Revisions			
P01	28.06.16	PLANNING ISSUE	AE PY
P02	14.07.16	REVISED PLANNING ISSUE	KI PY
P03	09.03.17	PLANNING AMENDMENT SUBMISSION	KI LP

**PLANNING AMENDMENTS**

**1 ELEVATION**  
 SOUTH EAST GA ELEVATION  
 1 : 500

Client  
 RFU  
 Project  
**TWICKENHAM STADIUM  
 EAST STAND EXTENSION**  
 Drawing title  
**GA ELEVATION 3**

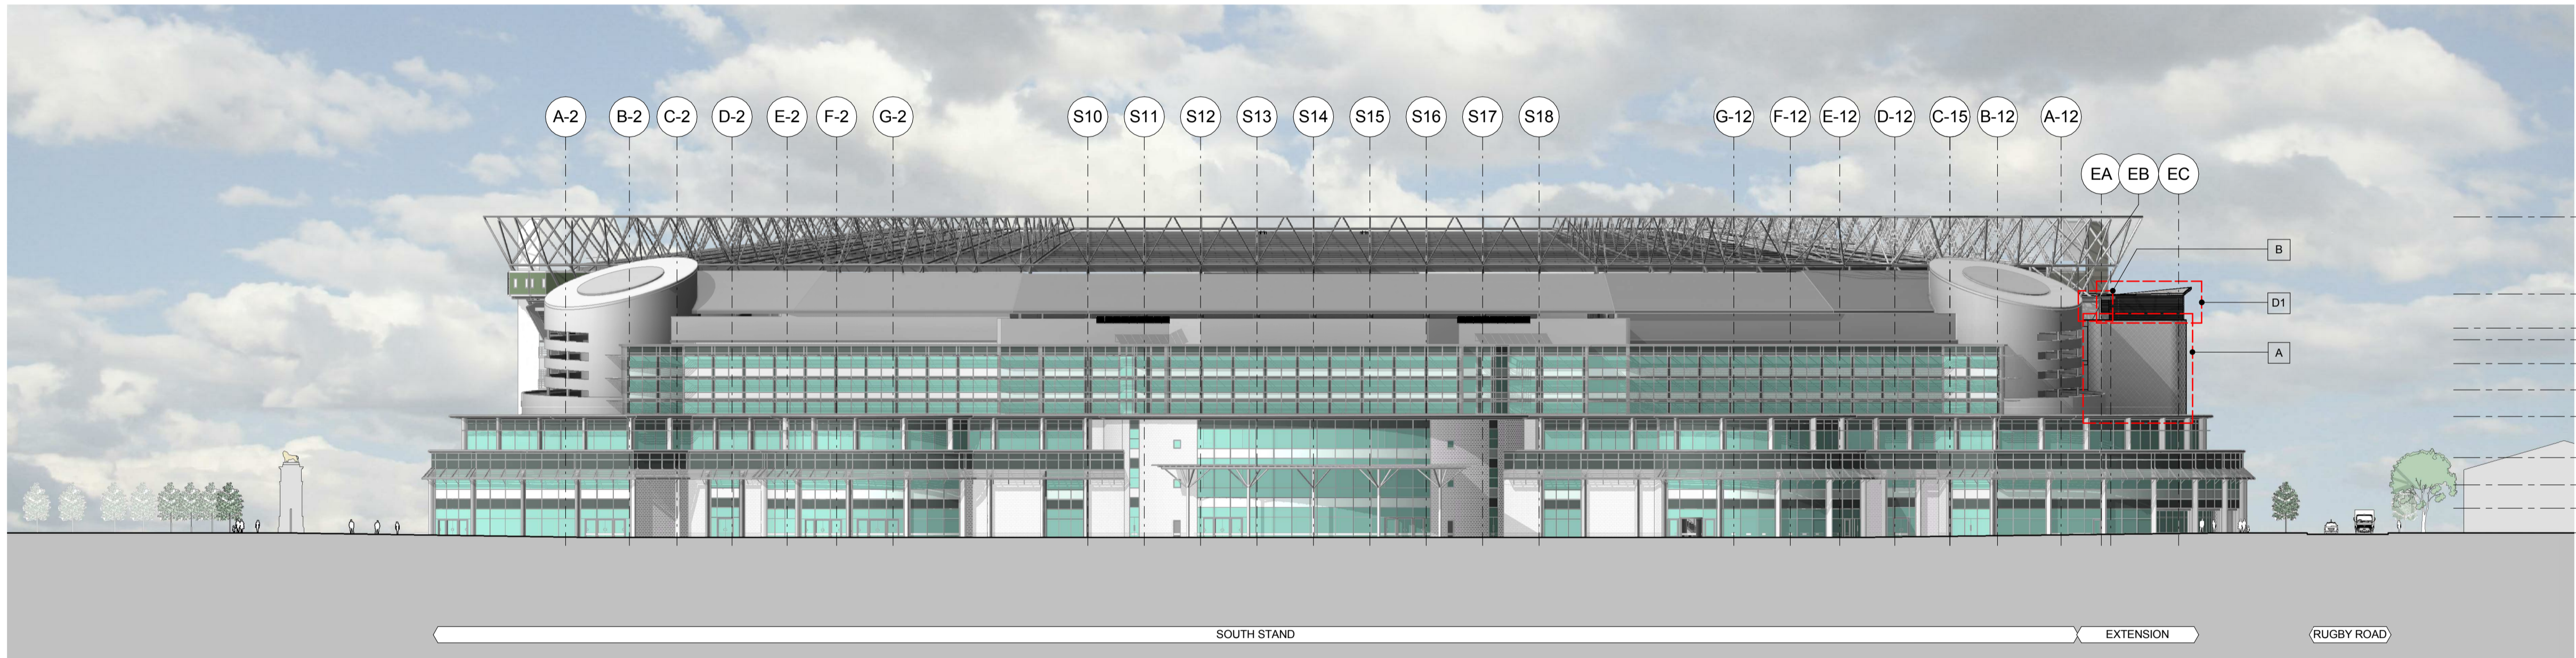
- A GENERAL AMENDMENTS TO THE SOUTH END.
- A1 INCREASED SHINGLES CLADDING AREA AND CURTAIN WALL REDUCED ACCORDINGLY.
- A2 REDUCED MASSING AND REVISED INTERFACE WITH THE SOUTH STAND.

- B PPC LOUVRES LOCATED TO THE BOWL SIDE HAVE BEEN OMITTED.
- C CURTAIN WALL SETTING OUT REVISED GENERALLY. SILICONE JOINTS TO TRANSOMS AND MULLION REPLACED WITH CAPPED SYSTEM. LEVEL 04 PPC LOUVRES SETTING OUT & HEIGHT REVISED. MONORAIL FOR ABSEILING REMOVED.

- D GENERAL AMENDMENTS TO THE CENTRAL ELEVATION CANOPY AT LEVEL 5A REVISED GENERALLY AND STANDING SEAM REPLACED WITH SINGLE PLY MEMBRANE. SUPPORT COLUMNS TO ROOF CANOPY REVISED. SQUARE FASCIA TO ROOF EDGE.

- D1 LEVEL 5A GLAZED SCREEN EXTENDED IN HEIGHT AND PPC LOUVRES INCLUDED AT LOW LEVEL.
- D2 INCREASED SHINGLES CLADDING AREA AND CURTAIN WALL AREA REDUCED ACCORDINGLY. FOUR VERTICAL FINIS REMOVED.

- D3 PORCELAIN PANELS WITH SLOTTED HOLES FOR VENTILATION REPLACED WITH PPC LOUVRES. EXPRESSED HORIZONTAL PATTERN TO PORCELAIN PANELS OMITTED.
- E GENERAL AMENDMENTS TO THE NORTH END PORCELAIN CLADDING REPLACED WITH PPC ALUMINIUM CLADDING.

- E1 GREEN WALL TO THE NORTH END EXTENDED AND PPC LOUVRES REMOVED.
- E2 INCREASED SHINGLES CLADDING AREA AND CURTAIN WALL REDUCED ACCORDINGLY.
- E3 FENCELINE, GATE AND PERIMETER COLUMNS SETTING OUT REVISED.

- F CANOPY TO TURNSTILES REVISED.
- F1 PORCELAIN PATTERN CHANGED FROM HORIZONTAL TO VERTICAL.
- G PORCELAIN PANELS TO THE SOFFIT OF THE ARCH REPLACED WITH PPC ALUMINIUM PANELS. PORCELAIN PANELS SETTING OUT REVISED.

- H ROOF TO LEVEL 5A (NORTH END) EXTENDED.
- K GLAZED SPANDREL PANELS REPLACED WITH METAL SPANDREL PANEL. PORCELAIN PANELS REPLACED WITH PPC ALUMINIUM CLADDING.

- L1 PPC LOUVRES INCLUDED FOR MECHANICAL VENTILATION.
